Addendum No.2
to
CONSTRUCTION DOCUMENTS
for

June 2, 2025
2023159.00

NCISD New District Administration Building
21330 Valley Ranch Parkway
New Caney, TX. 77357
June 2, 2025

B1 REFLECTED CEILING SECOND FLOOR PLAN - AREA A2

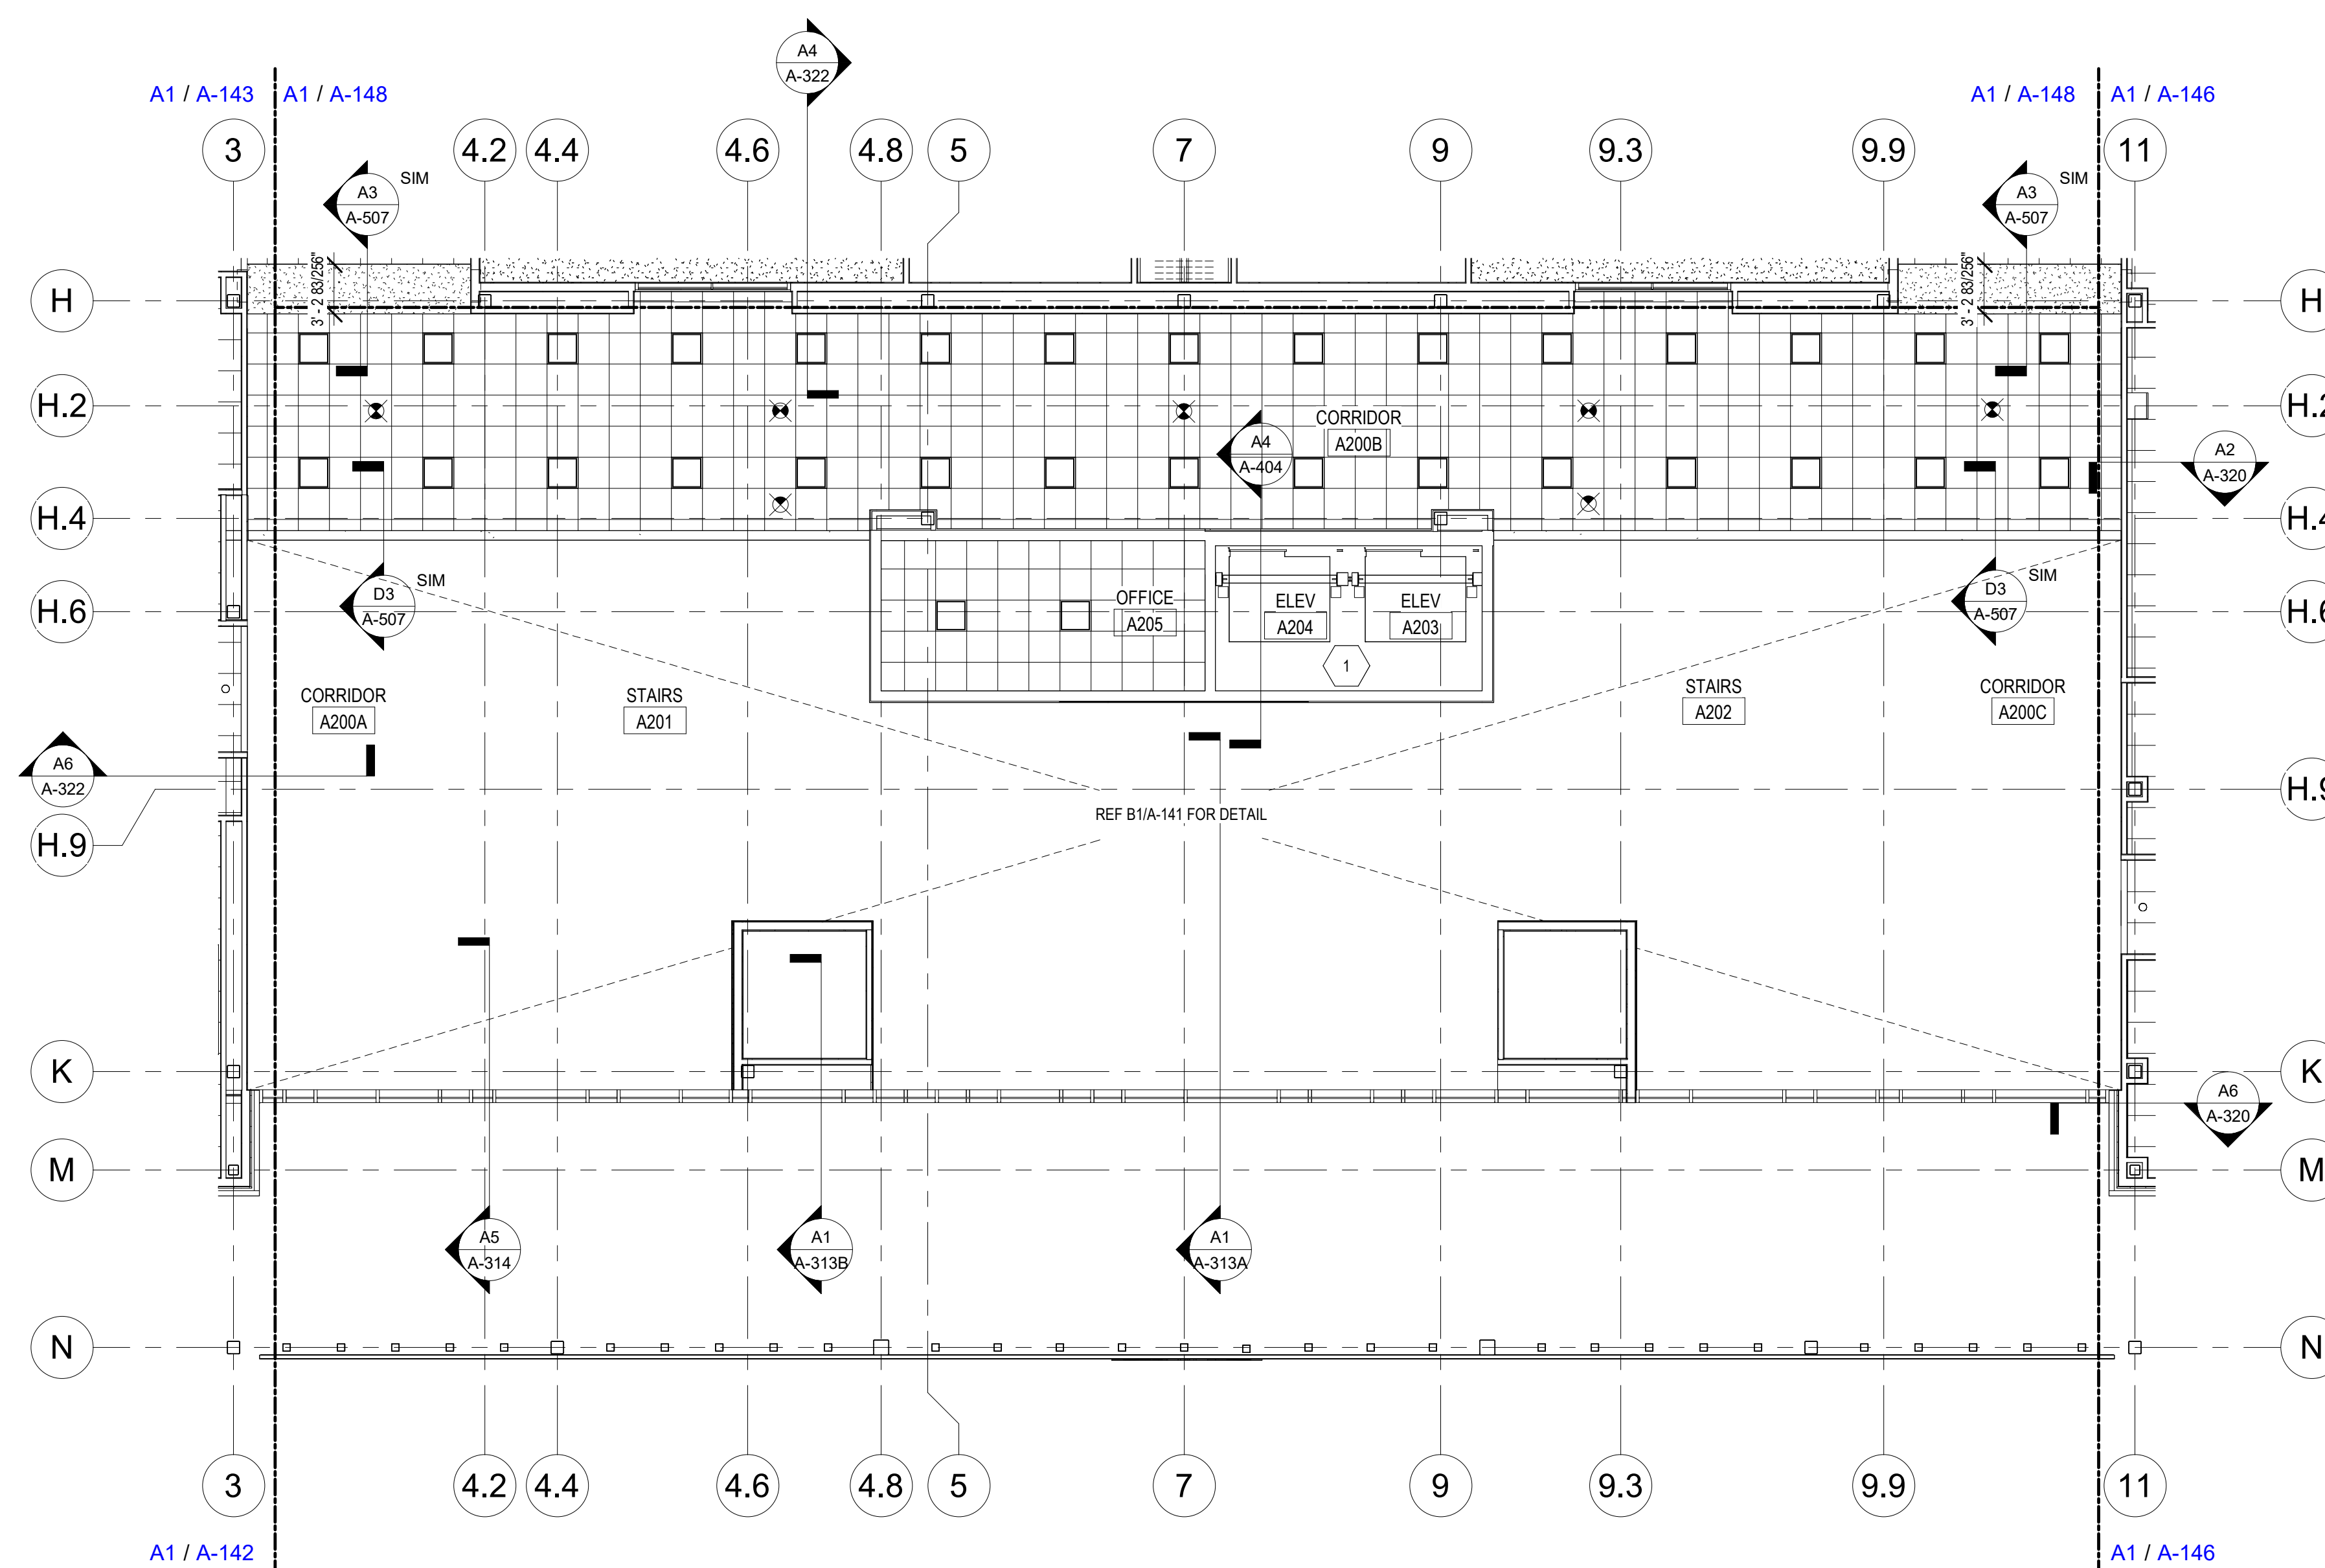
18. Sheet A-141 – Reflected Ceiling Second Floor Plan – Area A2
- a. Refer to Area 2 Reflective Ceiling second Floor Plan with added section callouts.
19. Sheet A-142 – Reflected Ceiling Second Floor Plan – Area B2

A-148

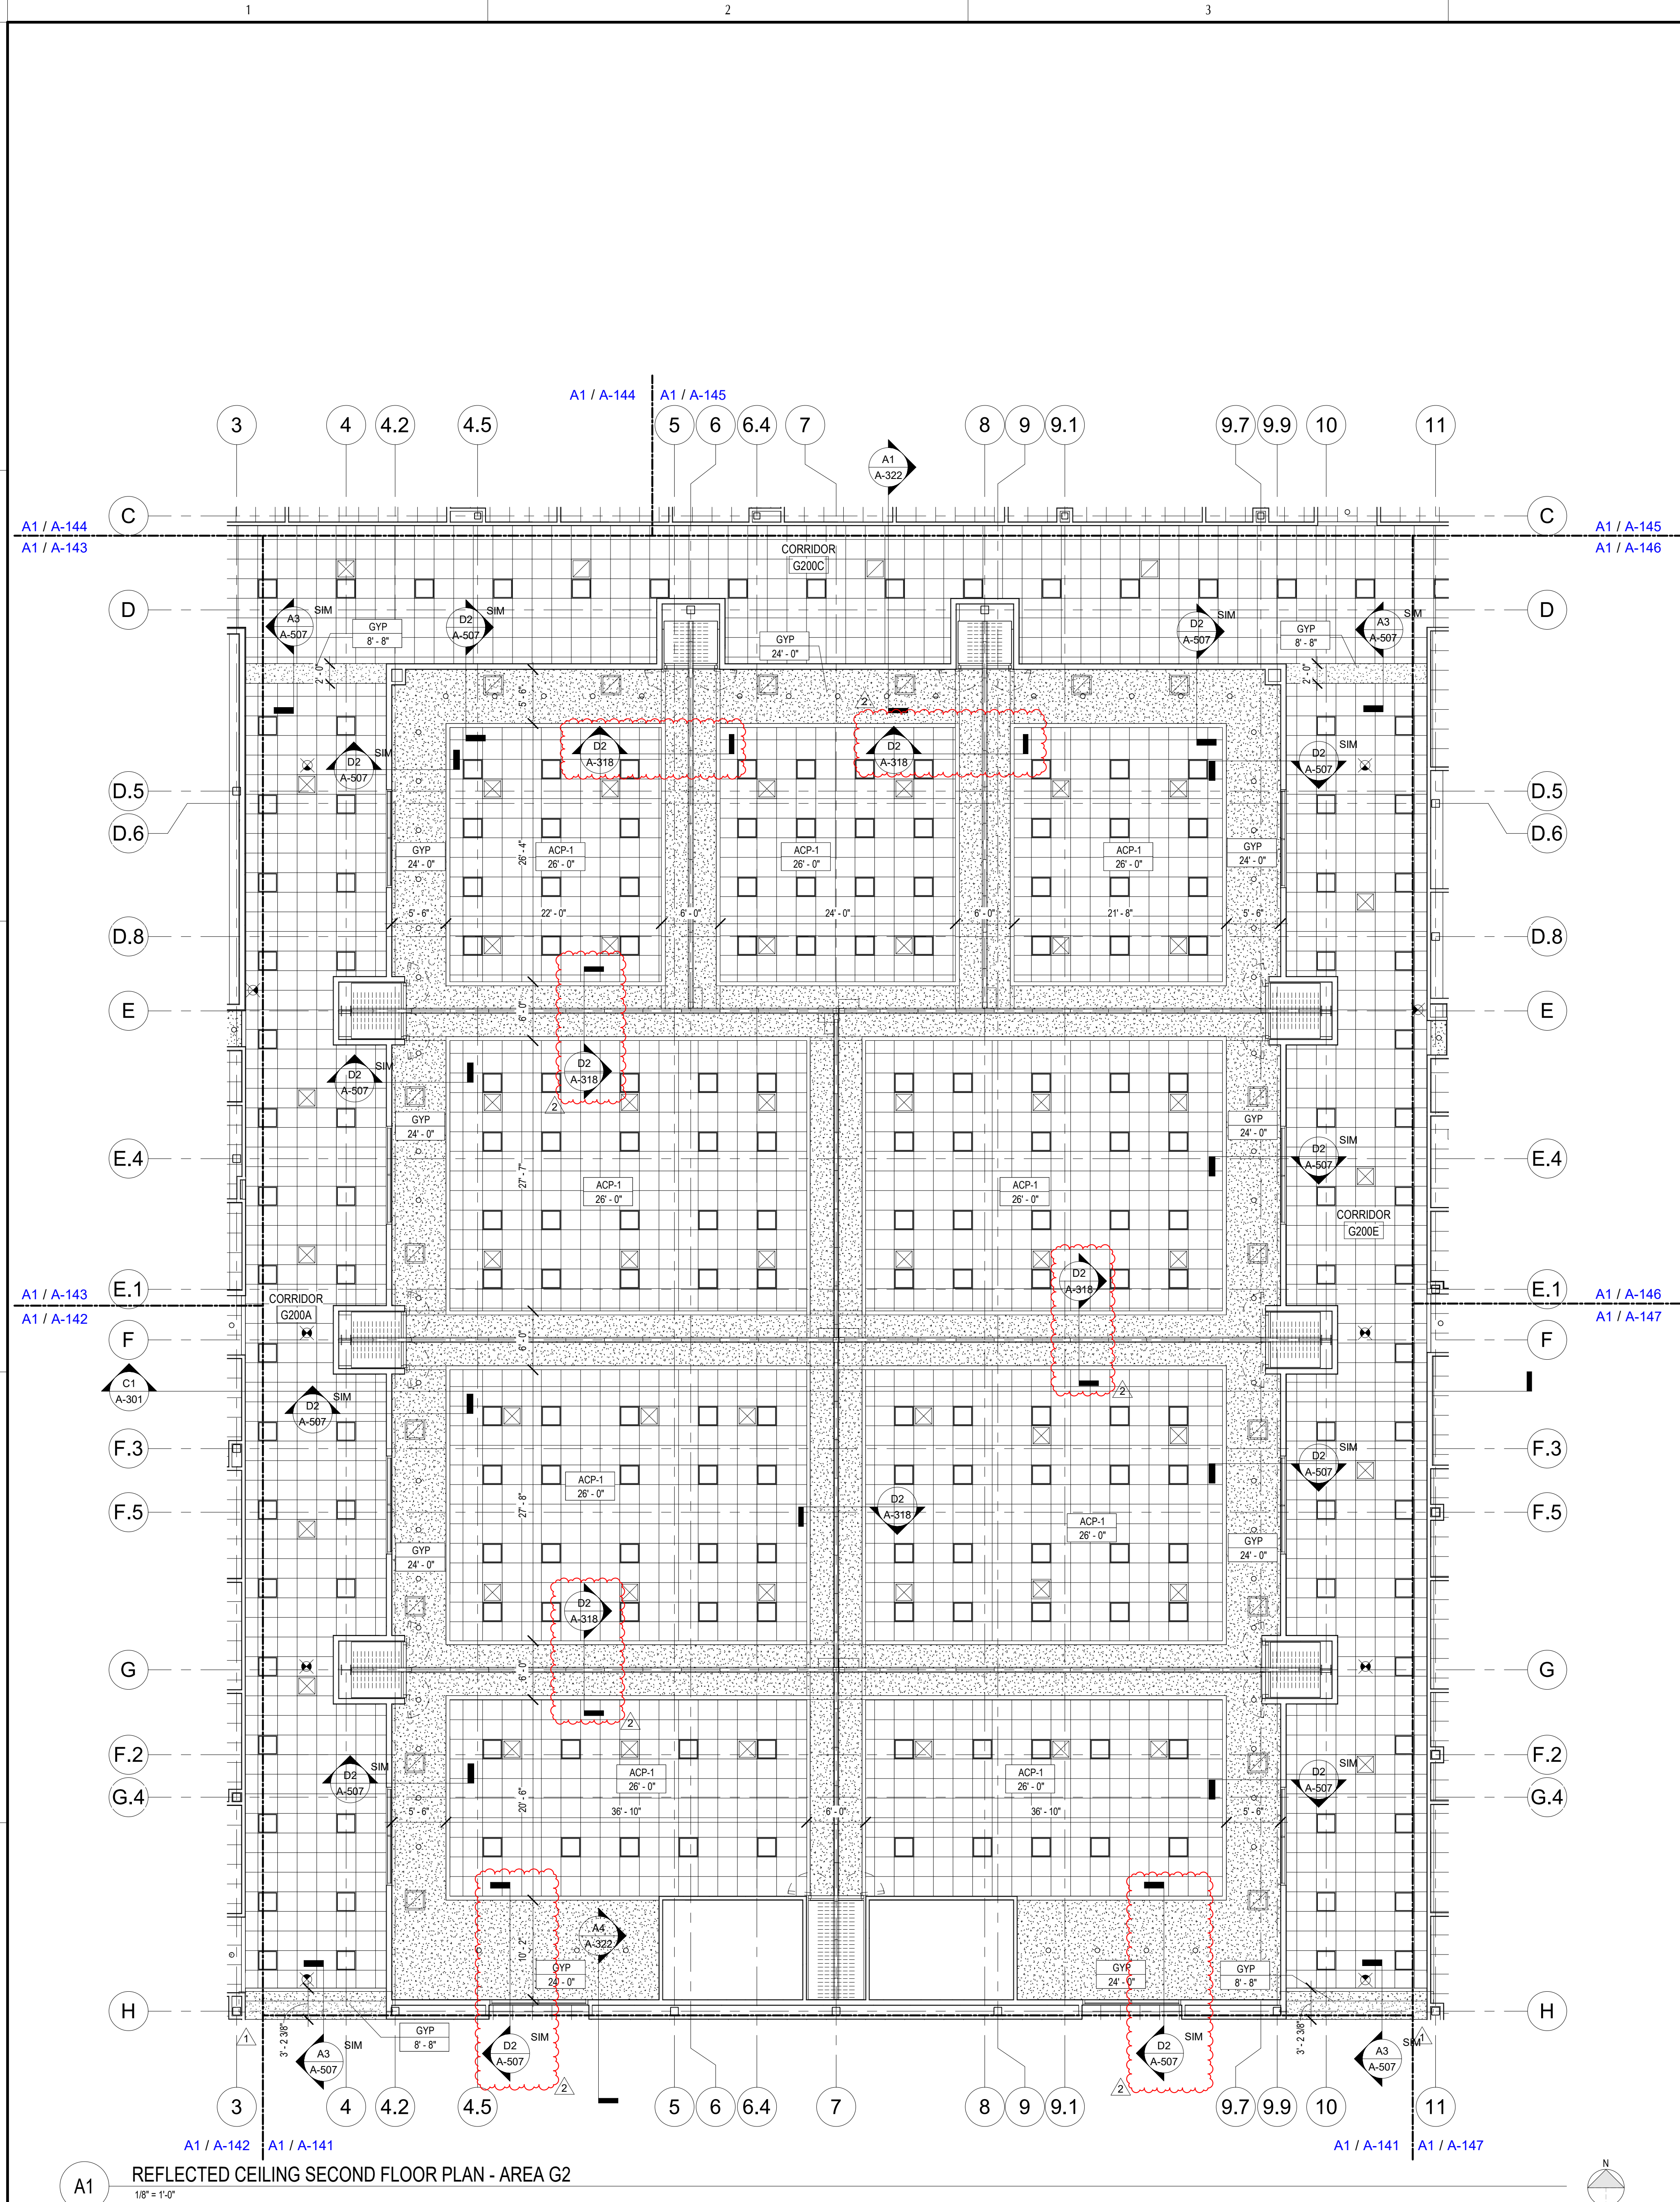
21. Sheet A-148 – Reflected Ceiling Second Floor Plan – Area G2
- a. Added callout to reference detail D2/A-318
22. Sheet A-150 – Composite Roof Plan
- a. Walk pad added to east and west clerestories.

A-154

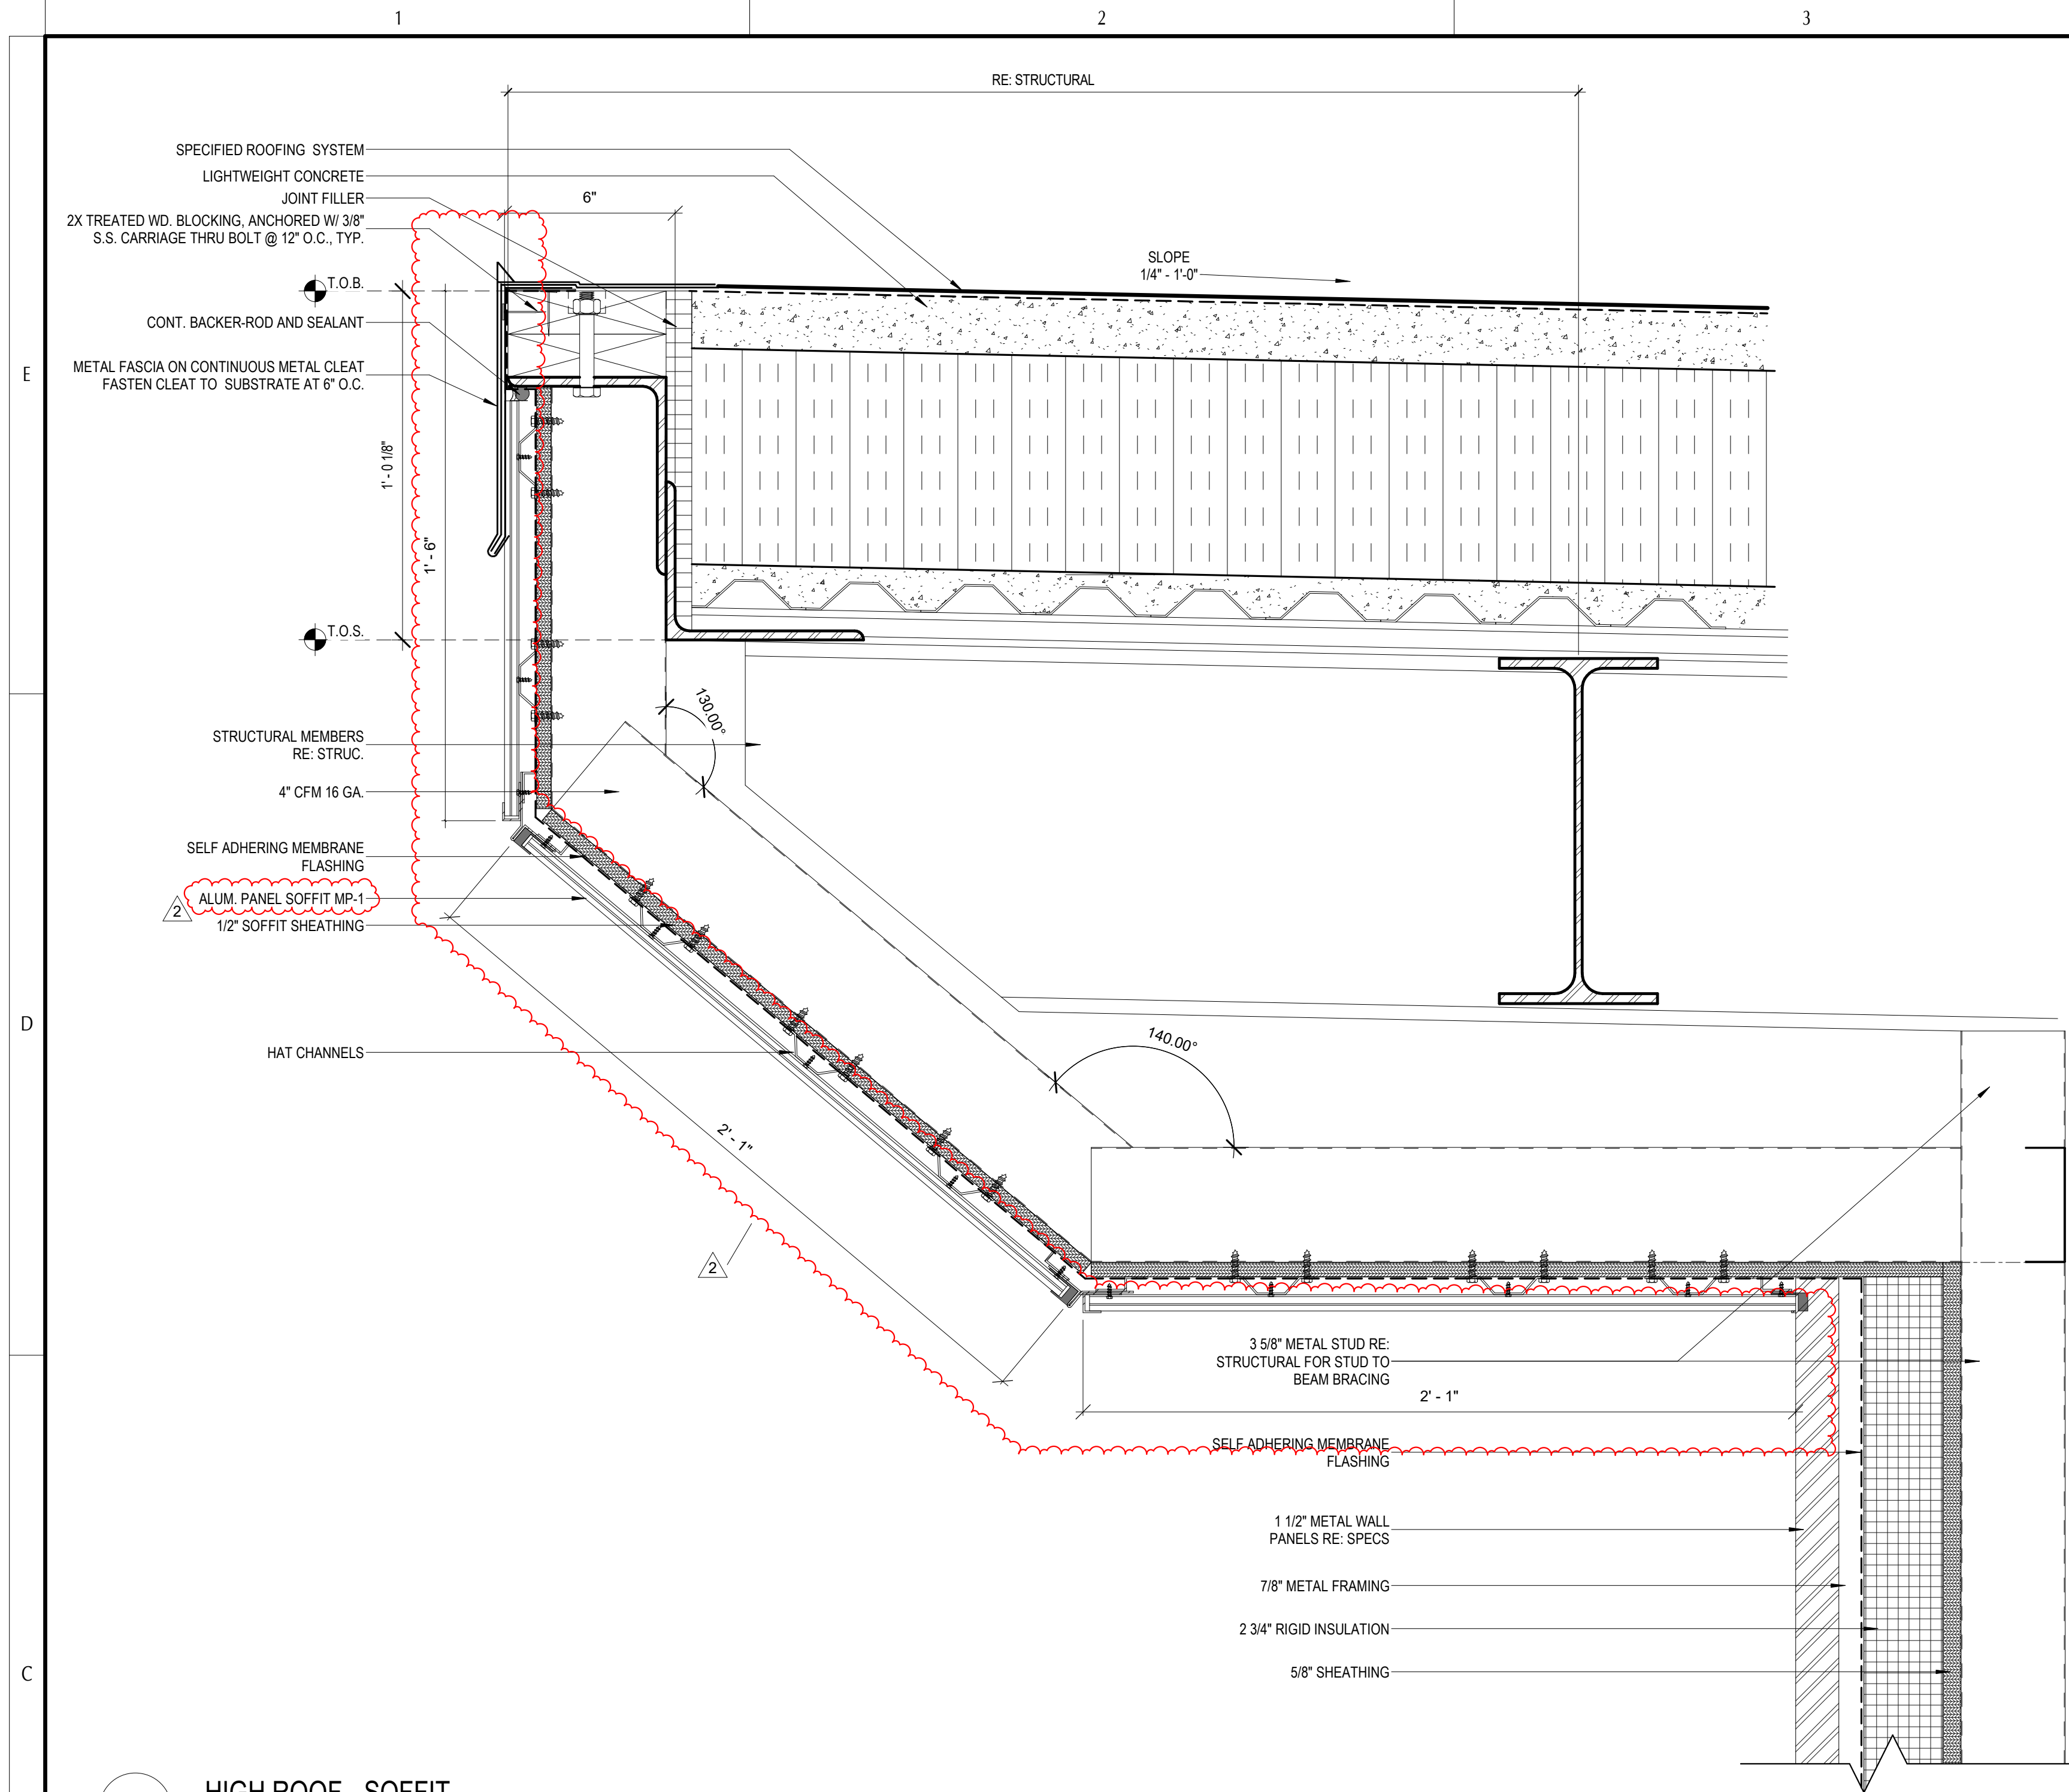
23. Sheet A-152 – Roof Plan – Area B & C
- a. Walk pad added to area B.
24. Sheet A-154 – Roof Plan – Area E & F
- a. Walk pad added to area F.
25. Sheet A-157 – Roof Details
